ADDENDUM NO. 2
Waterfront Park Shoreline Improvements

**HARRISON TOWNSHIP
 WATERFRONT PARK
 SHORELINE IMPROVEMENTS**
 ELECTRICAL SITE PLAN

ISSUED FOR: ADD 2	DATE: 4/10/24 MDC 4/29/24 MDC	BY: MDC
JOB NO. HSN6004.03D		
SHEET E-1.0

A EXISTING PANELBOARD MODIFICATIONS
NOT TO SCALE

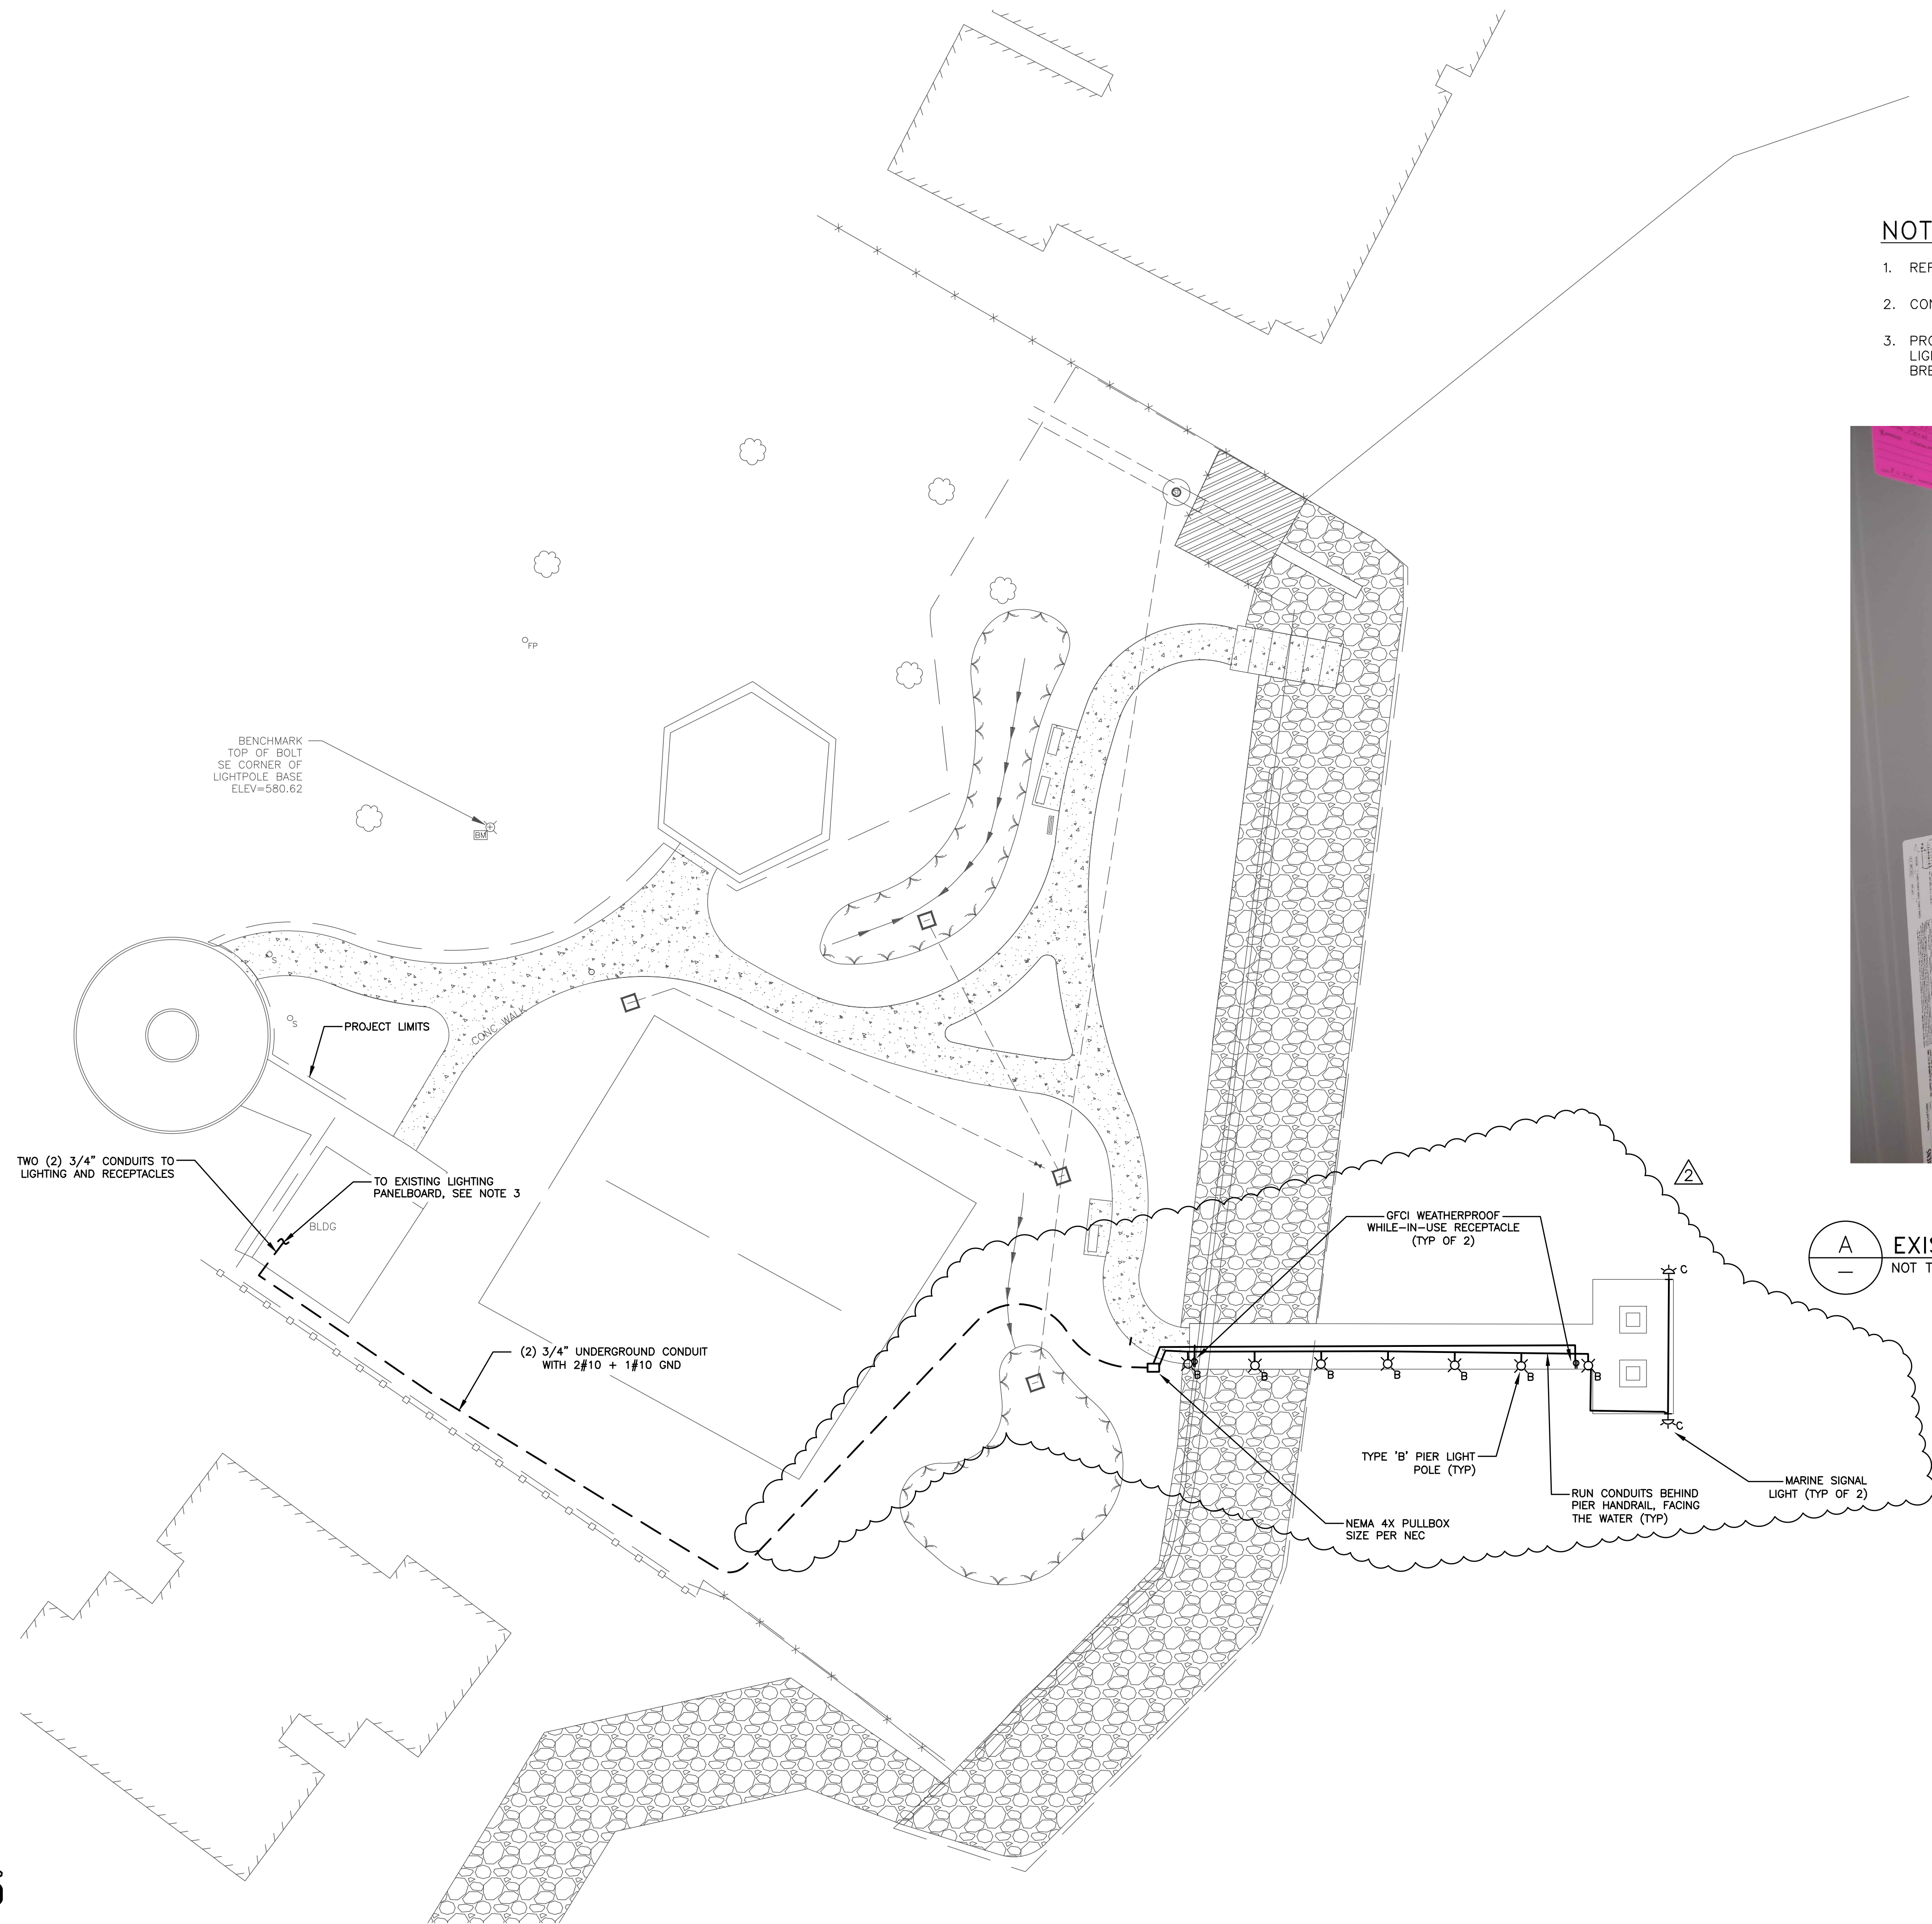
1. REFER TO SHEET E-1.1 FOR LIGHTING DETAILS.
2. CONTRACTOR MUST COORDINATE WITH EXISTING UTILITIES FOR ANY FIELD CONFLICTS.
3. PROVIDE (2) 20A CIRCUIT BREAKERS, 120V, 1 PHASE. ONE CIRCUIT BREAKER TO POWER THE LIGHTING AND THE SECOND ONE TO POWER THE OUTDOOR RECEPTACLES. PROVIDE CIRCUIT BREAKERS MATCHING EXISTING PANELBOARD RATINGS. SEE PHOTO ON THIS SHEET.

FURNISH NEW 20A CIRCUIT BREAKER. SEE NOTE 3
